**BELL BEND NUCLEAR POWER PLANT
DATA TO SUPPORT THE
WALKER RUN CLOMR REQUEST
BNP-2012-070 Docket No. 52-039**

Reference: 1) Case No.: 12-03-0820R
Walker Run
Community: Township of Salem, PA
Community No.: 420625

Bell Bend Nuclear Power Plant Flood Study Report Walker Run

Walker Run Flood Study Report

Appendix K:
Bridge Drawings

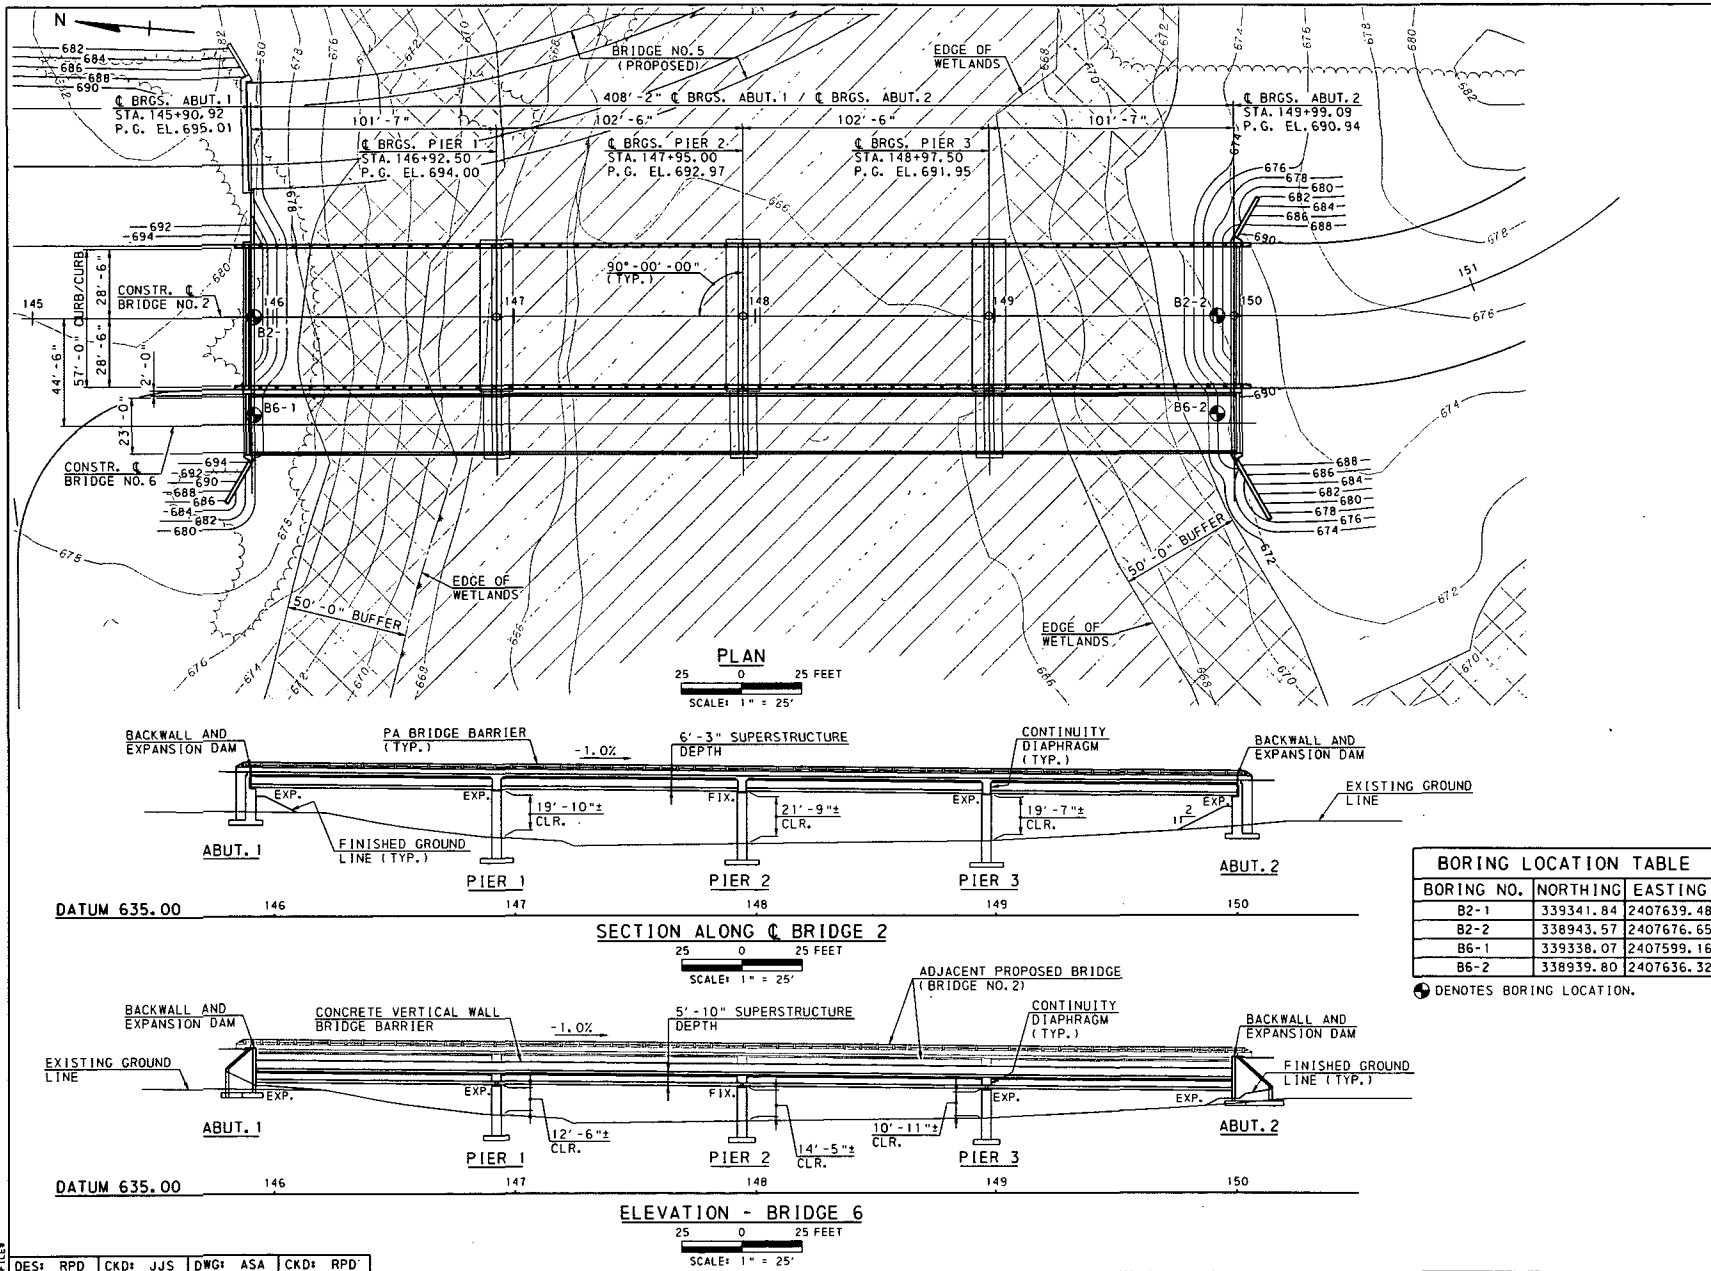
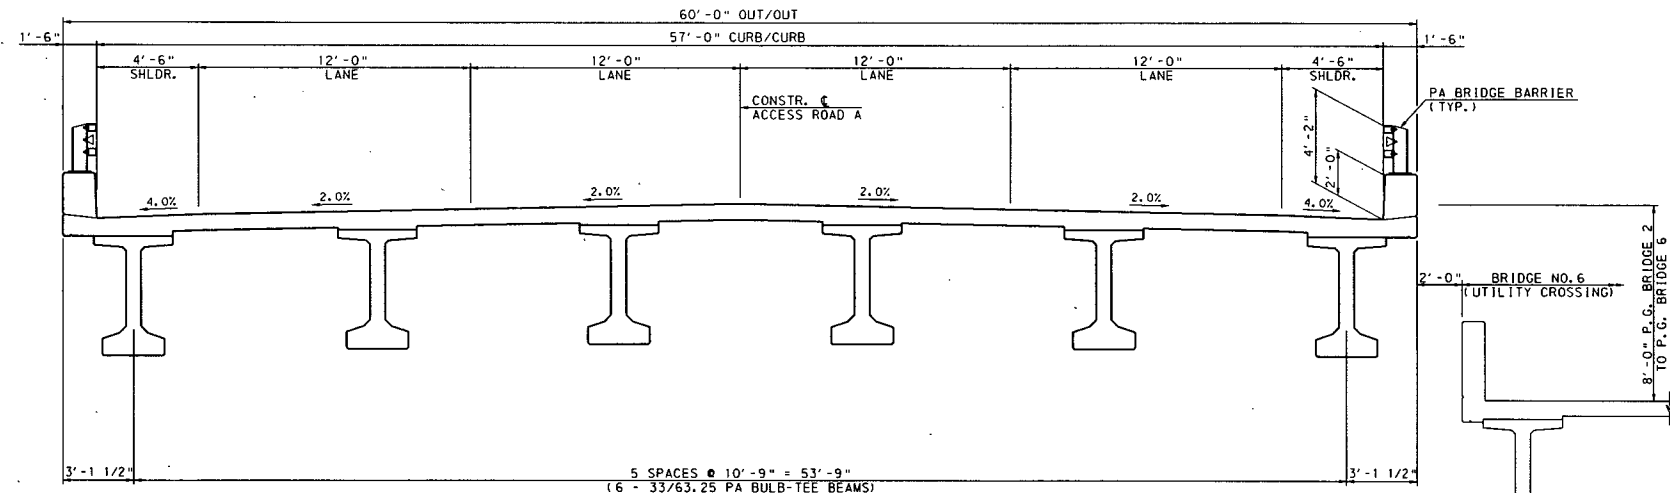
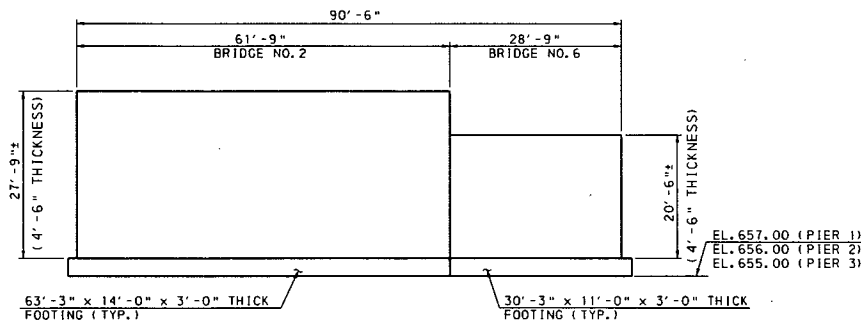
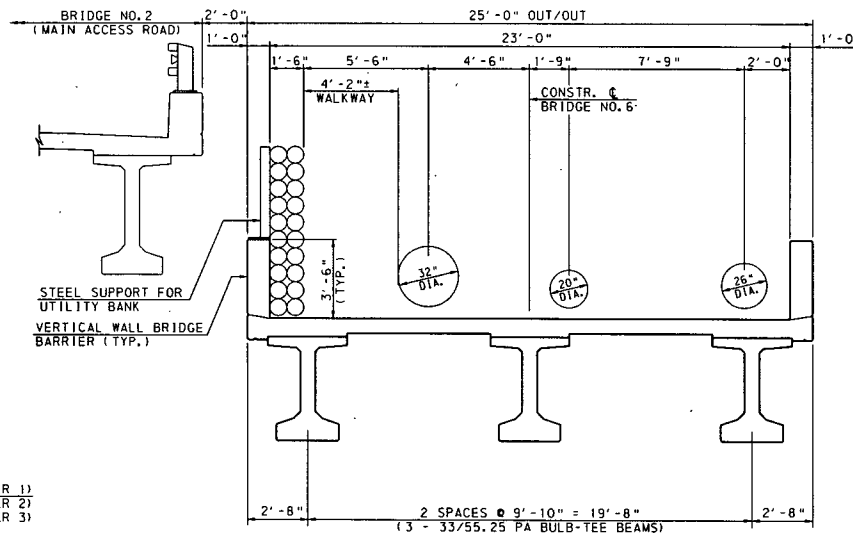
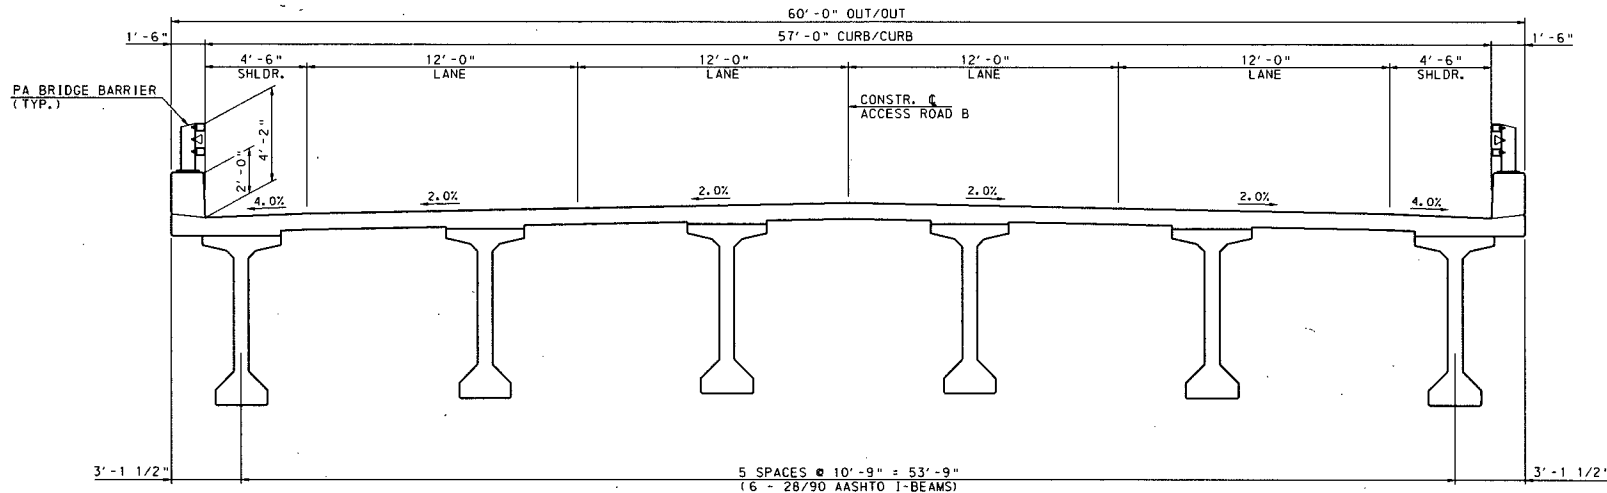
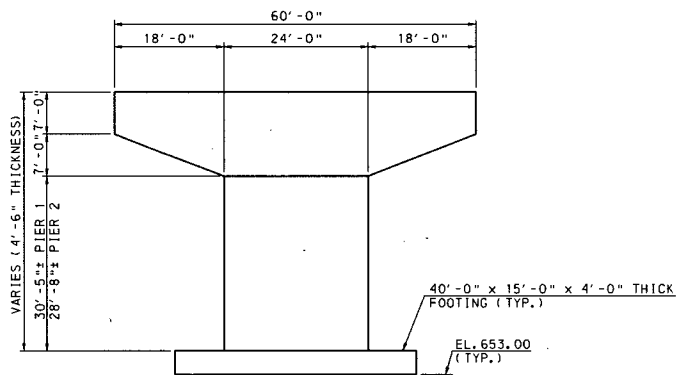
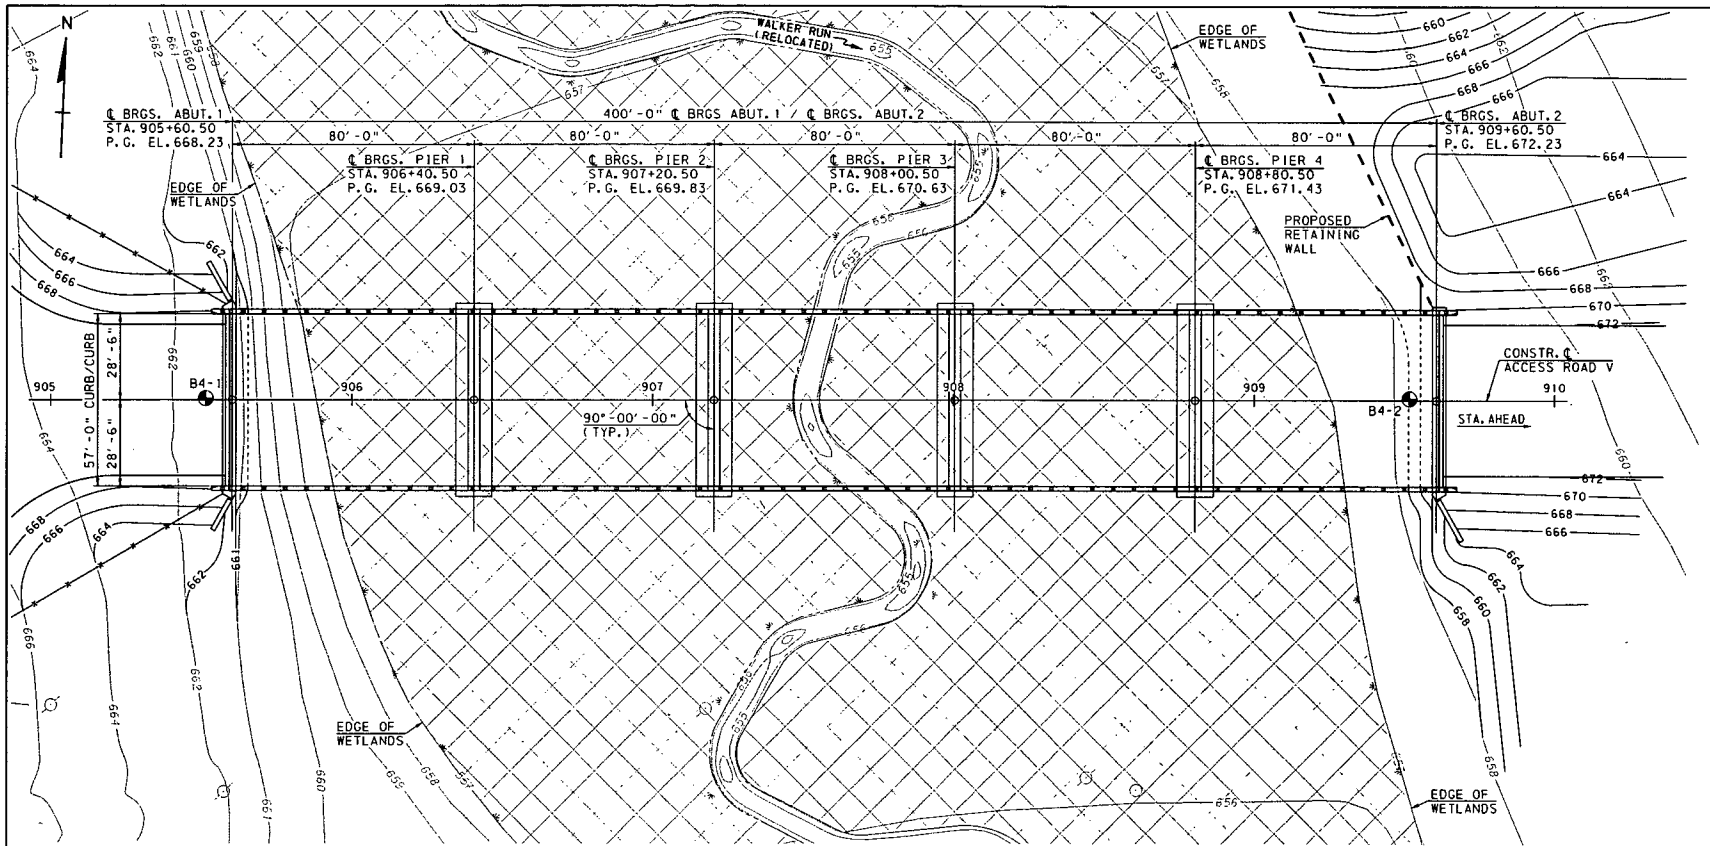
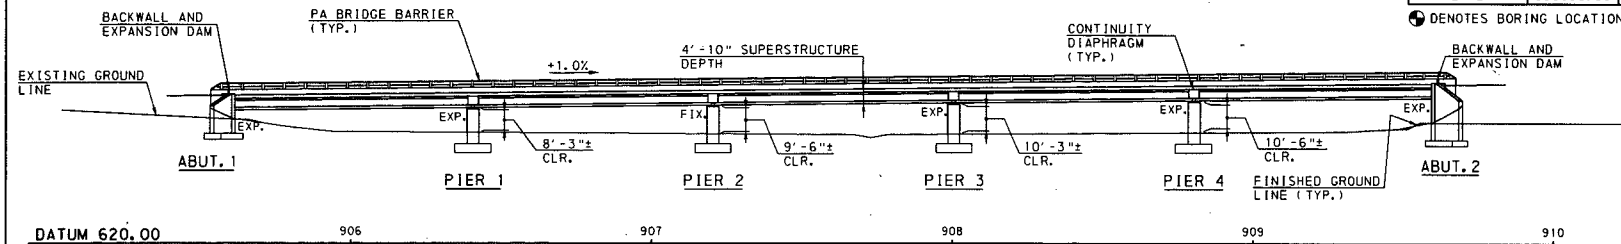
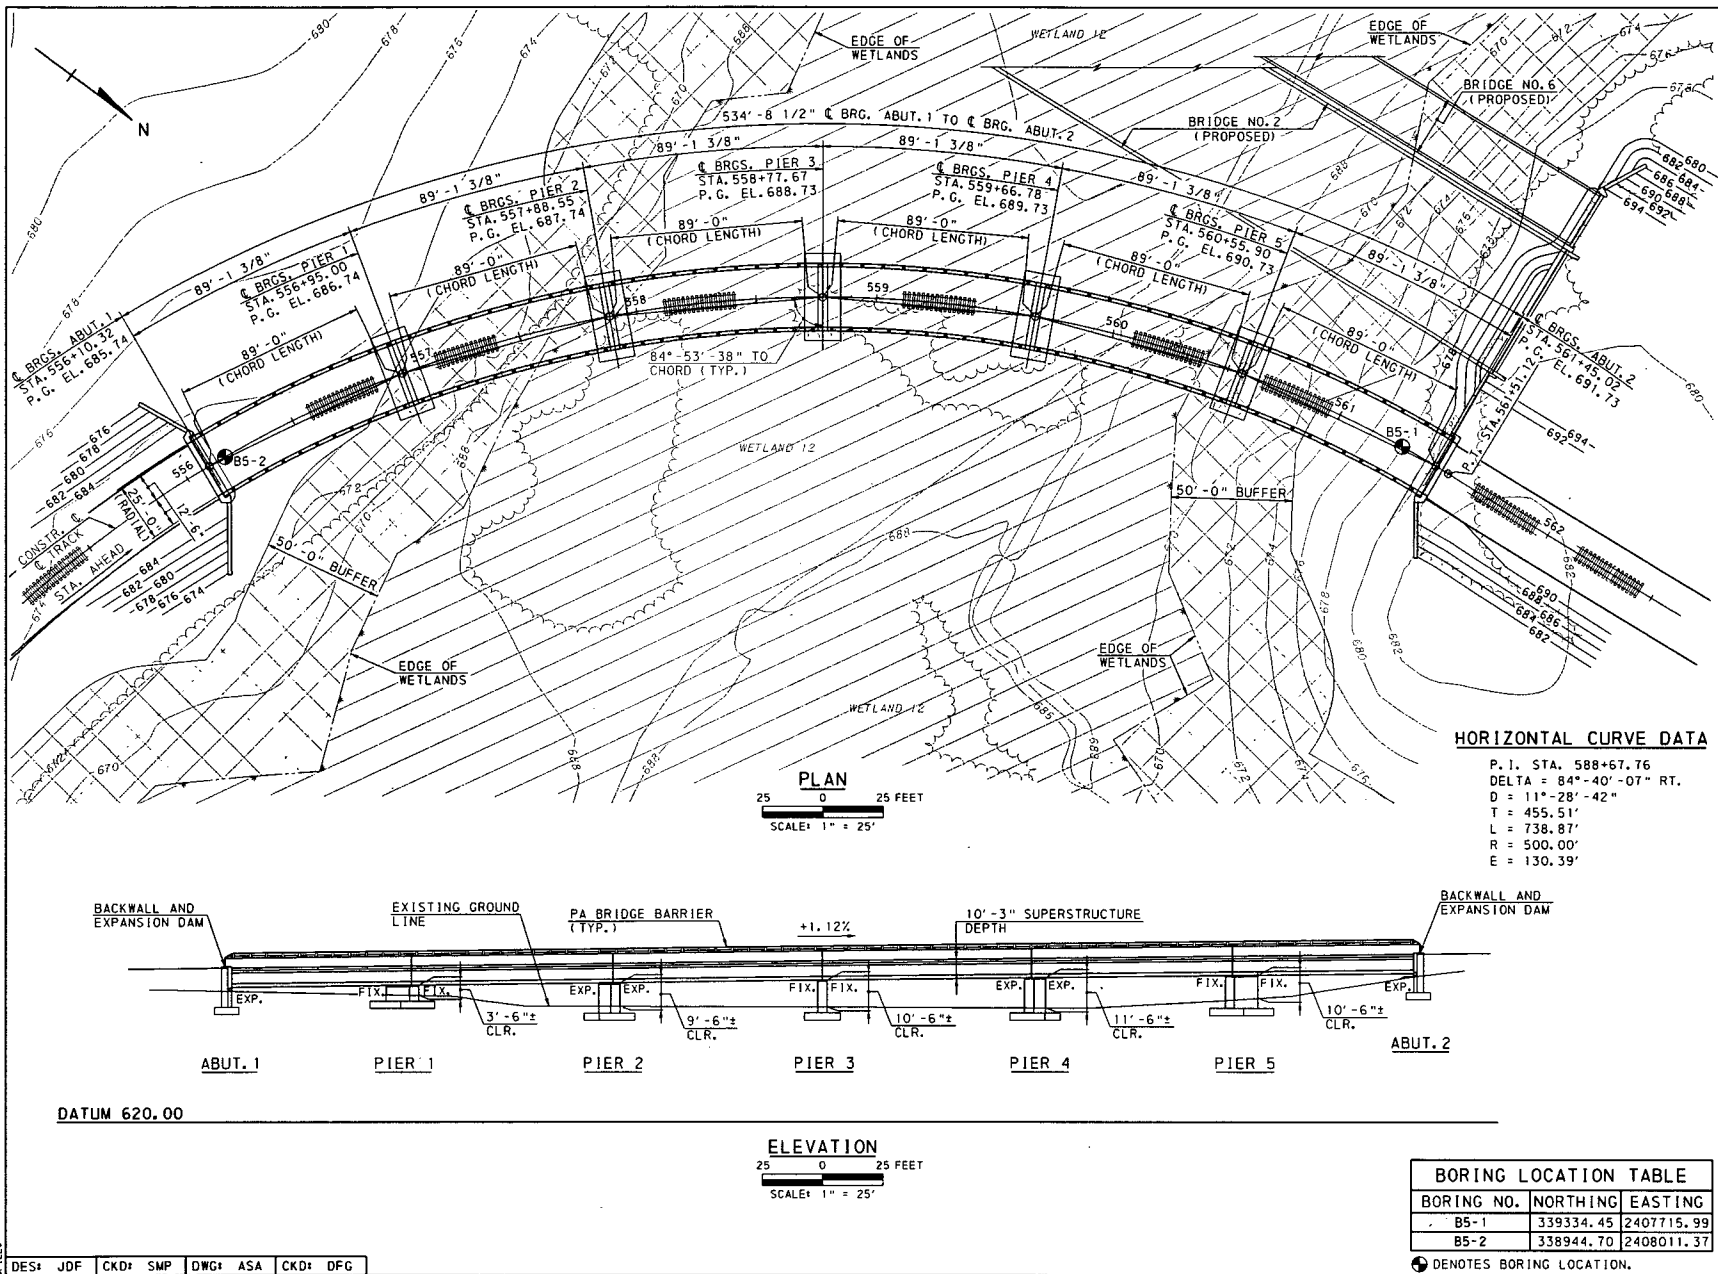
2. Our review of the submitted design plans for the proposed bridges over Walker Run and Unnamed Tributary to Walker Run revealed that they are not printed to the appropriate scale. Please submit all drawings to scale.

The bridge drawings were inadvertently copied at the wrong scale. Full size plan sheets have been included with this submittal.
